Recall Service Bulletin

APPLIES TO: This Recall service bulletin applies to certain 2018 and 2019 model year Gladiator and MetroStar model Emergency Response chassis cabs built between January 9, 2019 and March 12, 2019.

NHTSA/TC Id: 19V-360

FIG. 2-1

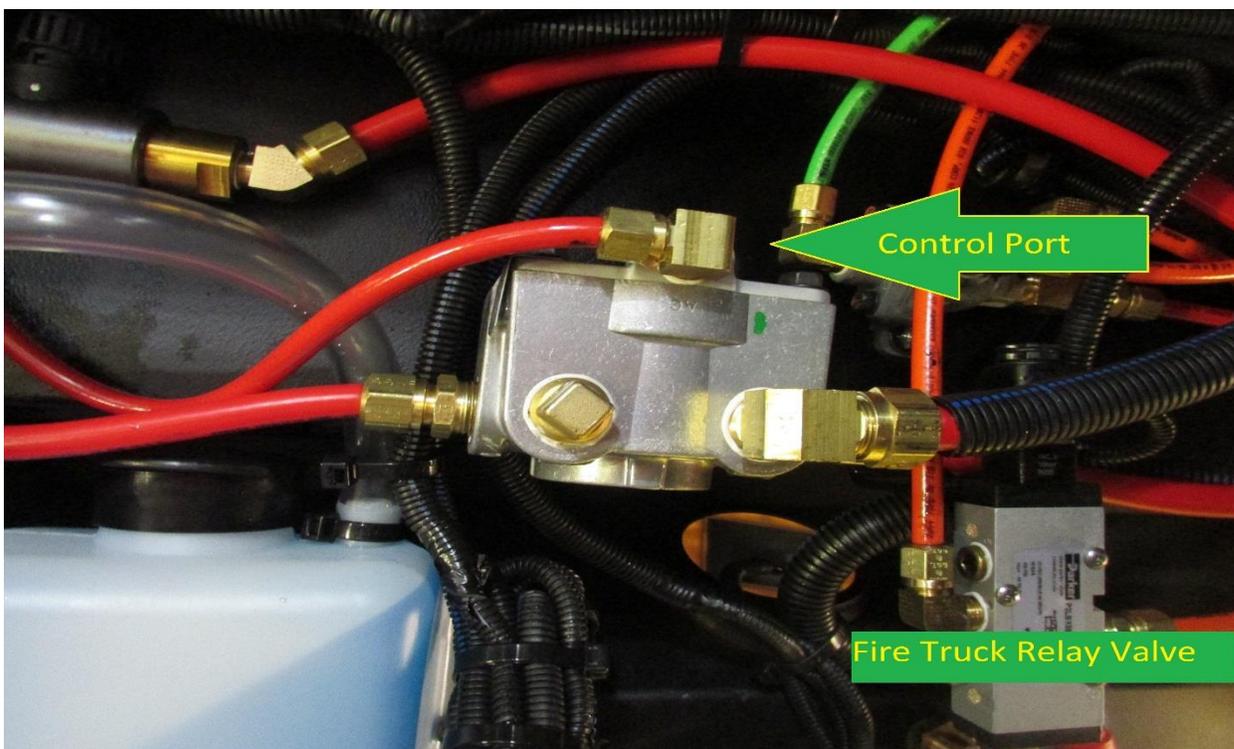
1. Tilt Firetruck cab. Make sure of the following before tilting cab:
 - Secure all items in cab
 - Check for clearances around cab
 - Make sure cab is tilted high enough to engage safety latch
2. Locate relay valve located behind drive side step well. Refer to FIG. 2-1.

Diagram 1

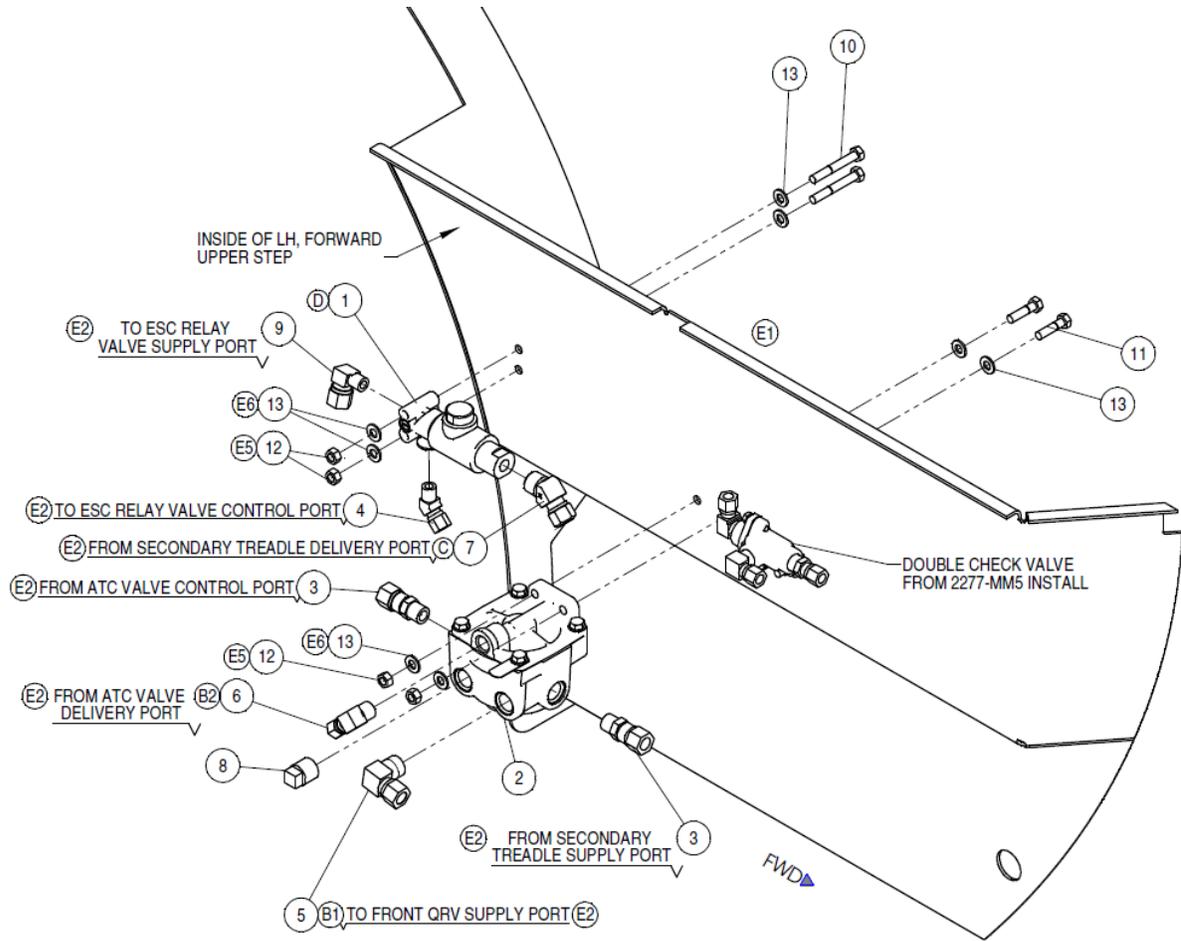
3. Remove relay valve. Be sure to mark all hoses for reinstallation.
4. Install new relay valve per Diagram 1.
 - a. Torque 5/16-18 nuts to 119 lbf-in.
5. Refer to Appendix A for fitting installation instructions.
